City of Massillon
Recreation Center

MEZZANINE POWER
AND COMMUNICATION
PLAN

ADD ALTERNATE #3
COMMUNITY ROOM
ELECTRICAL PLANS

Gymnasium Plan &
Locker Rooms-First Floor

ALTERNATE #3 - COMMUNITY ROOM POWER AND COMMUNICATION PLAN
1/8" = 1'-0"

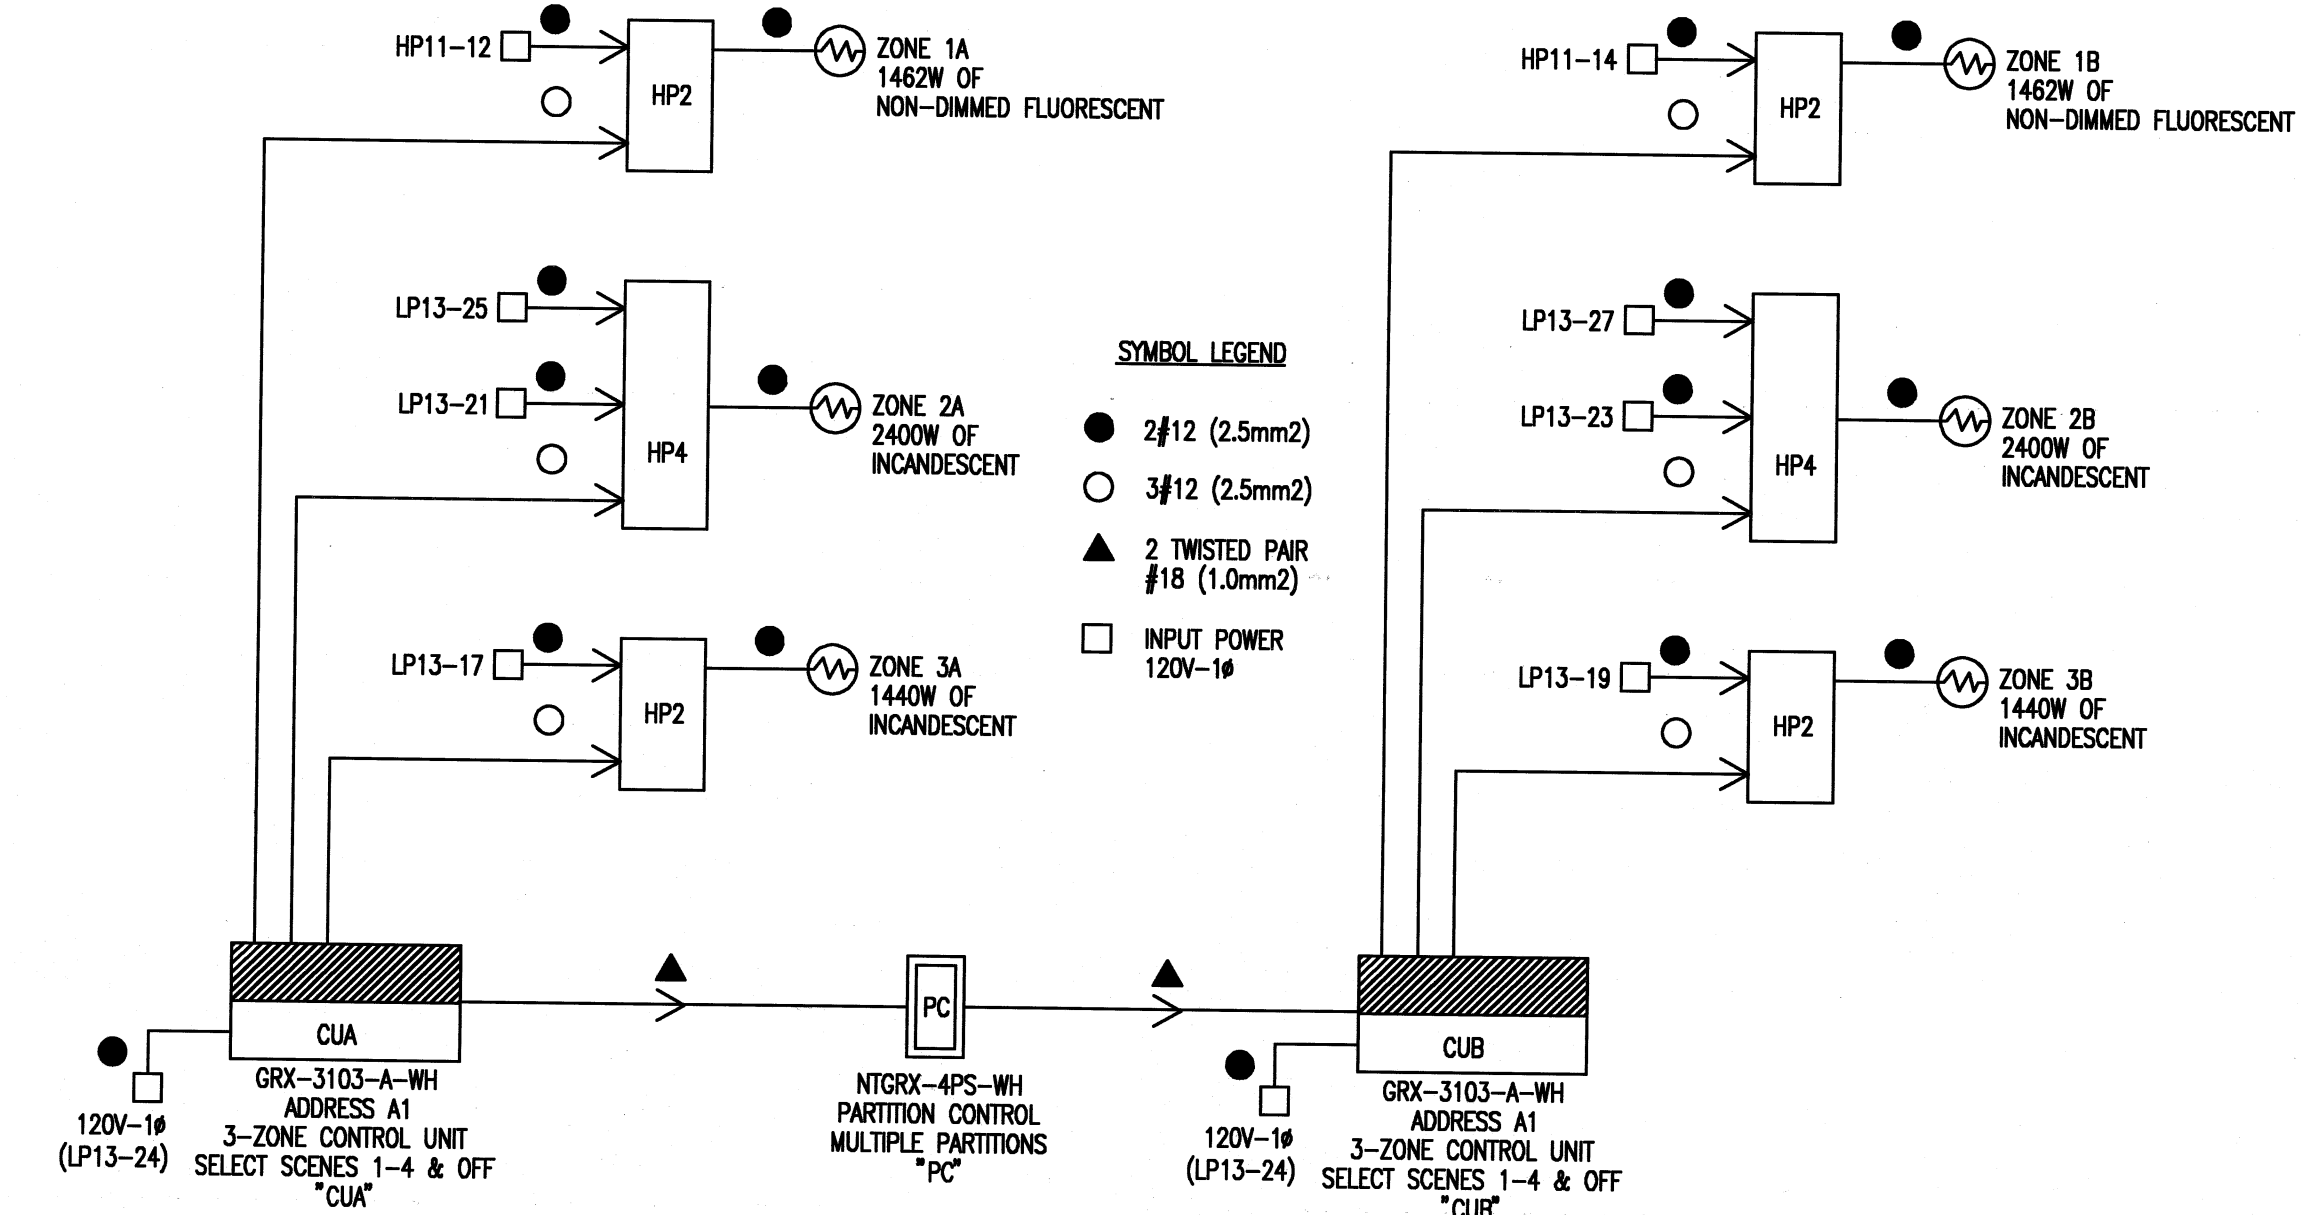
Is there a sound system for Alternate #3, Community Room?
Only power for a Community Room sound system is provided at this time.

ELECTRICAL SITE PLAN

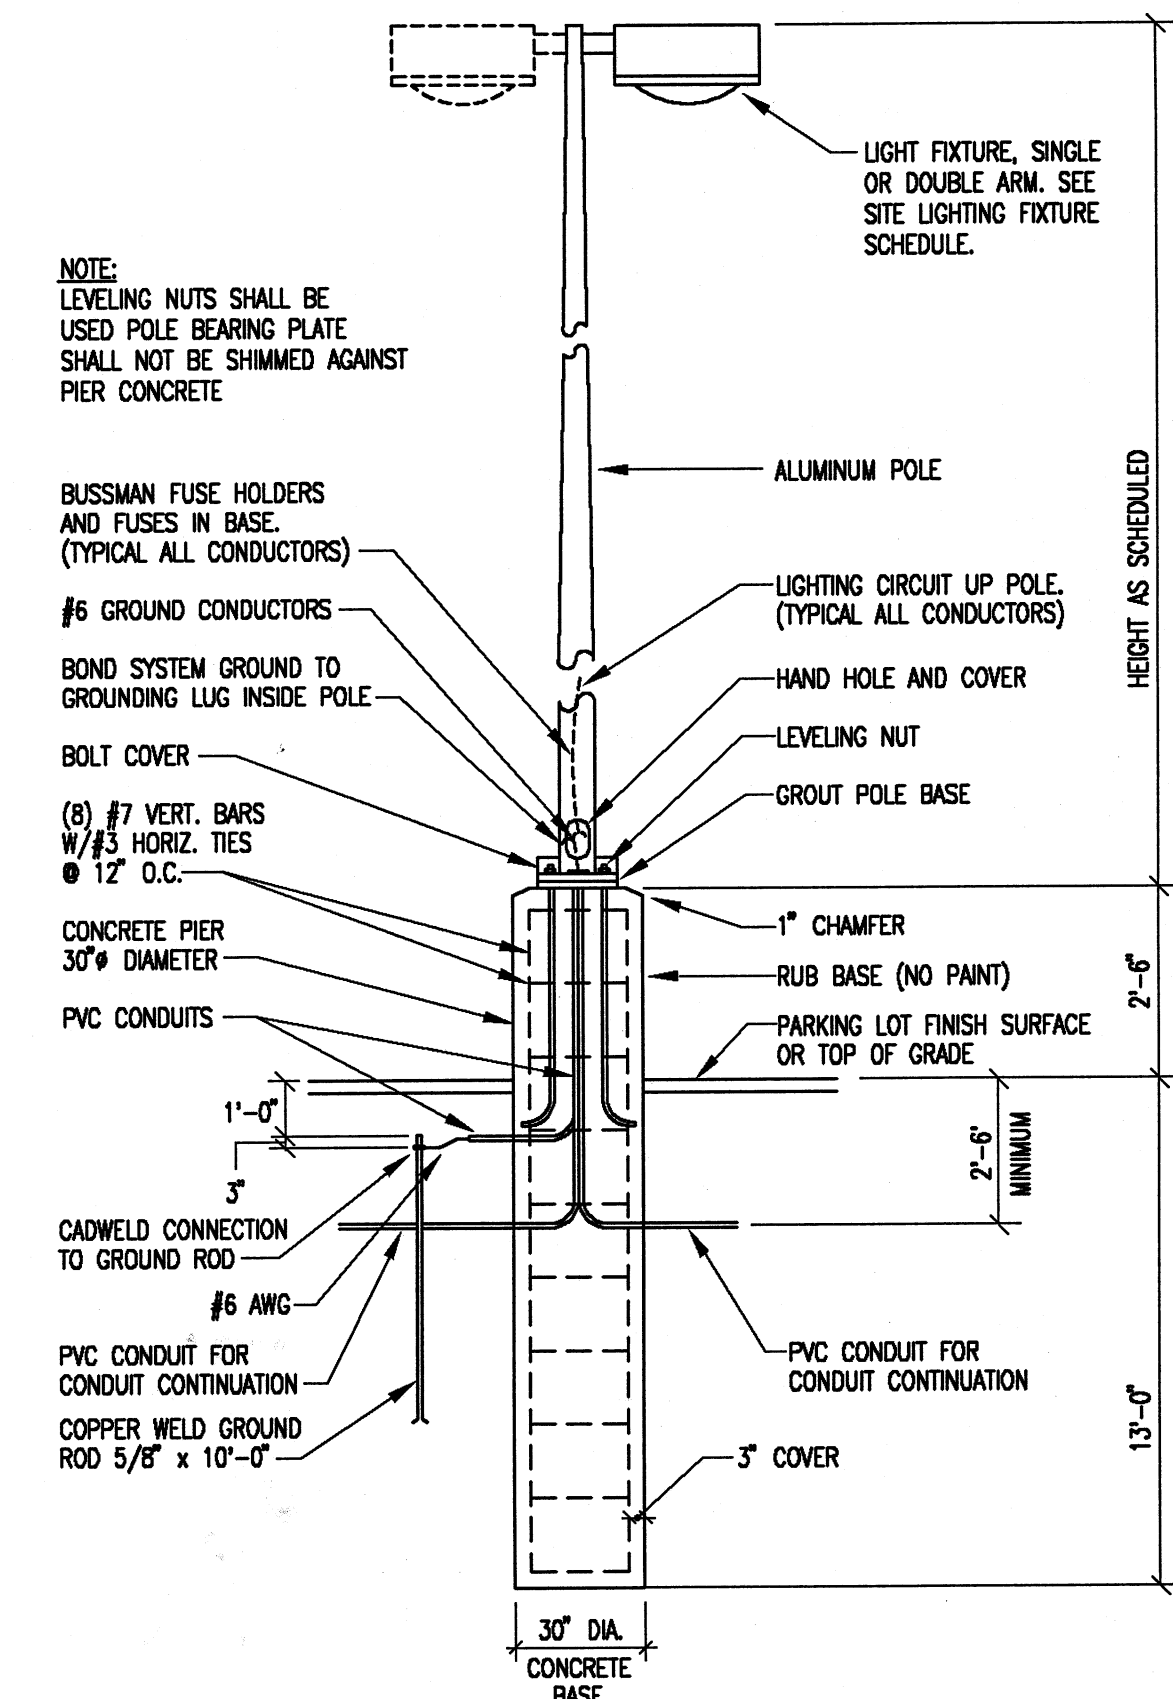
<i>City of Massillon</i> <i>Massillon Recreation Center</i>	Proposal Request No. <i>Addendum #1</i>
<i>Construction (05000.00)</i>	Date <i>3/14/01</i>
<i>Item 10th Pace Westlake</i>	Ref. Drawing No. <i>E-3-1</i>
<i>The Huntington Building</i> <i>822 North Avenue Suite 1000</i> <i>Cleveland, OH 44115-1007</i>	Sketch No. <i>606-C-19</i>

THE E.C. SHALL PROVIDE AN ADD ALTERNATE PRICE FOR THE THREE ADDITIONAL LIGHTS AT THE LOWER PARKING AREA AND ALL RELATED GROUNDING, POWER WIRING, POLE BASES, ETC. AS REQUIRED FOR A COMPLETE INSTALLATION.

THE E.C. SHALL PROVIDE AN ADD ALTERNATE PRICE FOR A LIGHTNING PROTECTION SYSTEM PER THE PERFORMANCE SPECIFICATION INCLUDED IN THE CONTRACT DOCUMENTS (ELECTRICAL SPECIFICATION SECTION 16670). THE SYSTEM SHALL COVER THE ROOF AREA OF THE MAIN BUILDING, CANOPY, AND ROOF AREA OF ALTERNATE #3 IF ACCEPTED. AREAS OF FUTURE EXPANSION SHALL NOT BE INCLUDED.
